Access Compliance Report

Public Rights-of-Way

(Curb Ramps)

Intersection ID: 2961	Main Street: GOLDENFIELD_DR	Cross Street: OLD_WILLOW_RD	Location: SE
ADA ID: E620600DA429	Ramp Type: Perp	Initial Pass/Fail: Fail	Overall Compliance: No
Severity Score: 22.5			
Codes/Mitigation Info/Possible Solution		Field Measurements/Component Compliance

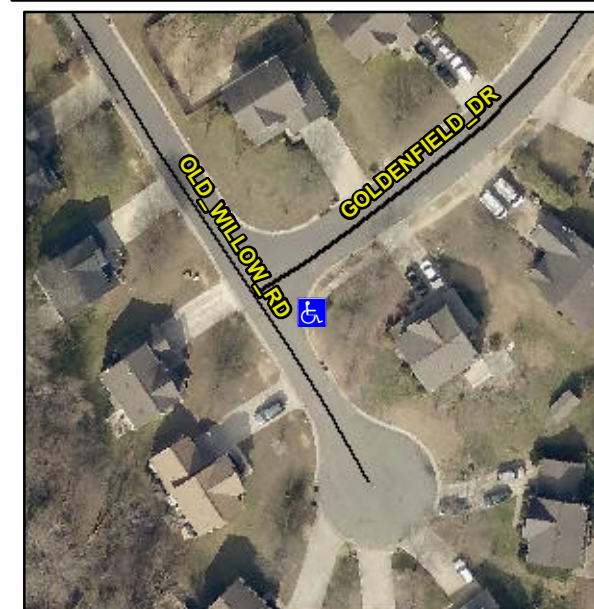
Not Found, R304.5.1, R304.2.2

Compliance	Description	Data	Compliance	Description	Data
N/A	Ramp Length (in)	48.0	No	Ramp Slope (%)	8.6
No	Ramp Width (in)	44.5	Yes	Ramp XSlope (%)	3.3
N/A	Flare Type LT	N/A	N/A	Flare Type RT	N/A
N/A	Flare Slope LT (%)	N/A	N/A	Flare Slope RT (%)	N/A
N/A	Flare Traversable LT?	N/A	N/A	Flare Traversable RT?	N/A
N/A	Landing Length (in)	N/A	N/A	DWS Provided?	N/A
N/A	Landing Width (in)	N/A	N/A	DWS Contrast?	N/A
N/A	Landing Slope (%)	N/A	N/A	DWS Length (in)	N/A
N/A	Landing X Slope (%)	N/A	N/A	DWS Full Width?	N/A
N/A	Landing Curb? (Y/N)	N/A	N/A	DWS Offset (in)	N/A
N/A	Shared Landing?	N/A			
N/A	Gutter Ponding?	N/A	N/A	Gutter Slope (%)	N/A
N/A	Gutter Lip Ht (in)	N/A	N/A	Gutter X Slope (%)	N/A
N/A	Painted X Walk1?	No	N/A	Painted X Walk2?	N/A
	X Walk 1 Direction	To W		X Walk 2 Direction	N/A
N/A	X Walk 1 Width (in)	N/A	N/A	X Walk 2 Width (in)	N/A
	X Walk 1 Slope (%)	1.8		X Walk 2 Slope (%)	N/A
	X Walk 1 X Slope (%)	4.6		X Walk 2 X Slope (%)	N/A

Remove & Replace Entire Ramp.
